# CONVAIR

## COMMERCIAL CHANGE PROPOSAL

SPEC NO.: ZD- 22-003

MODEL: 22-2 (Convair "880")

Enclosure: (A) One copy Page 38a - MAIN LANDING GEAR SYSTEM (Revised)  
(B) One copy Page 38b - WHEEL BRAKE (Revised)

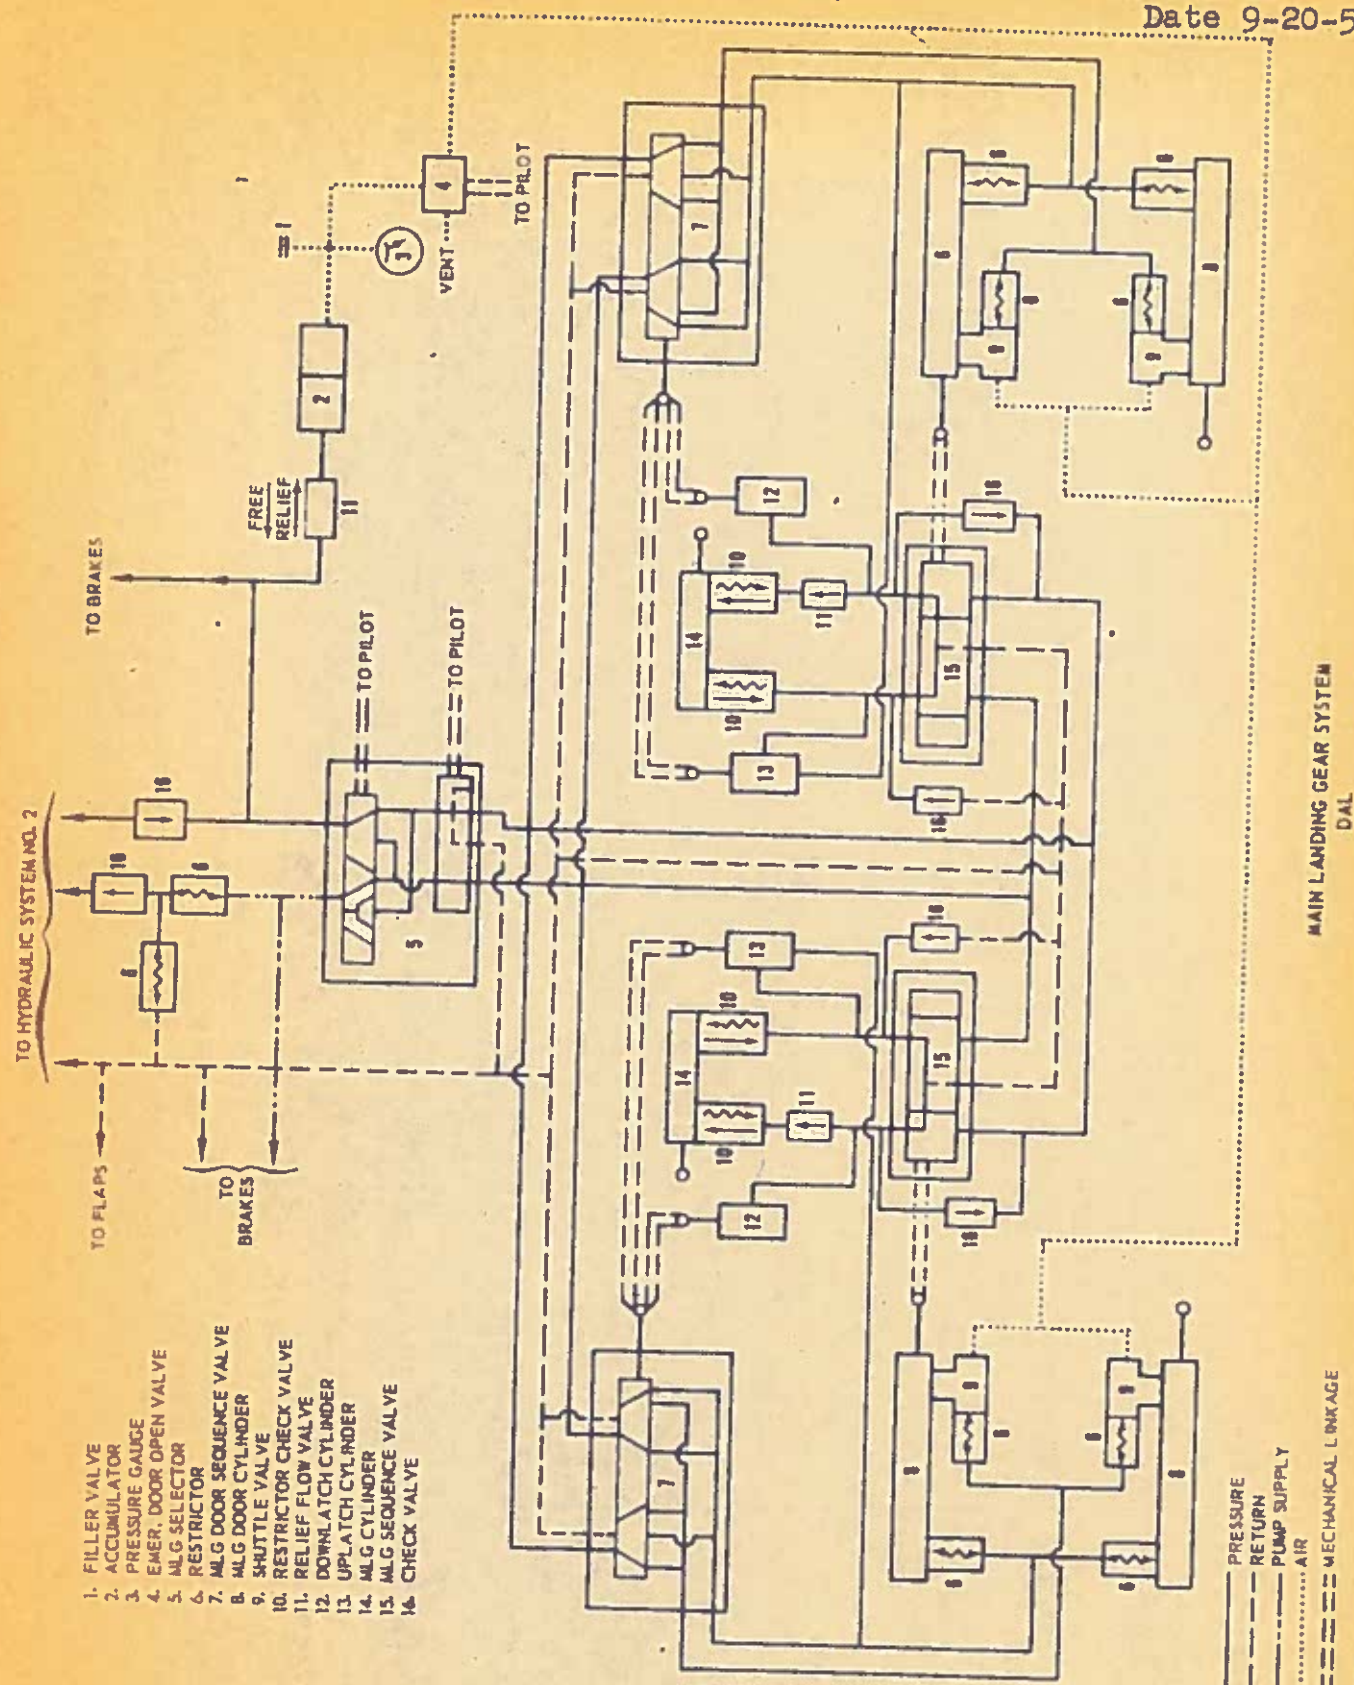
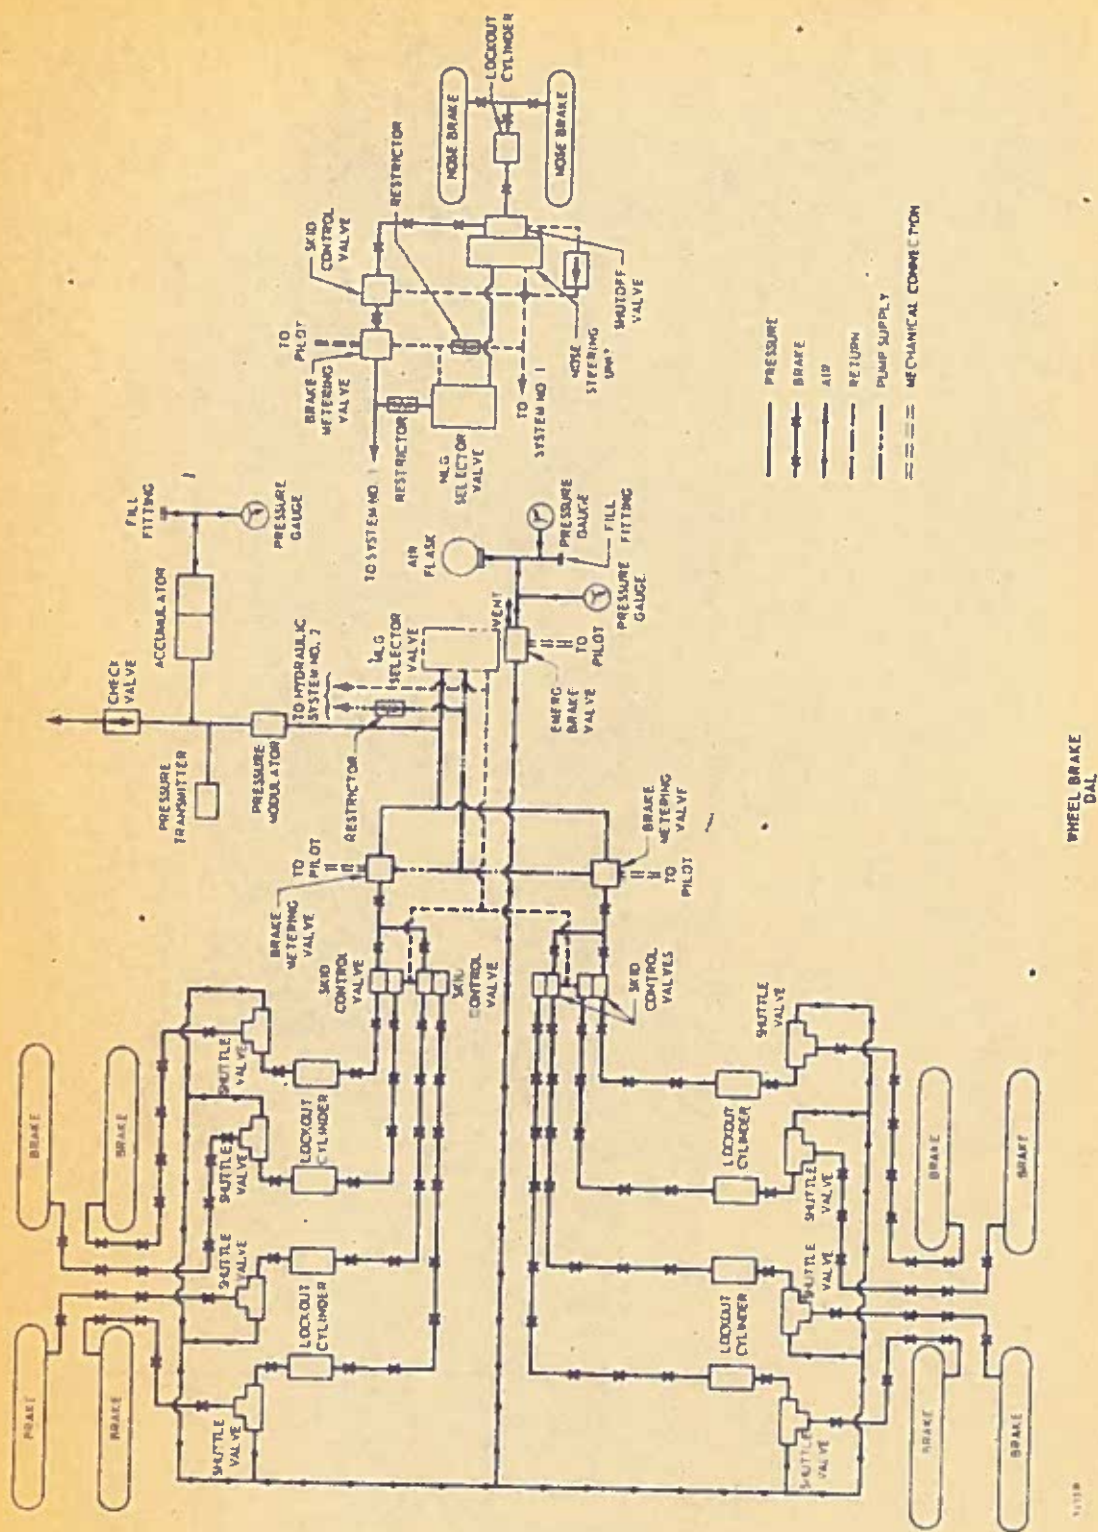
Delete the paragraph and substitute the following:

"Landing gear retraction shall be accomplished hydraulically to a point where the gear is within the wheel well cavity and the landing gear doors are closed in a maximum of ten seconds with four engines operating. Under three-engine operation conditions, the gear retraction cycle shall not exceed 12 seconds."
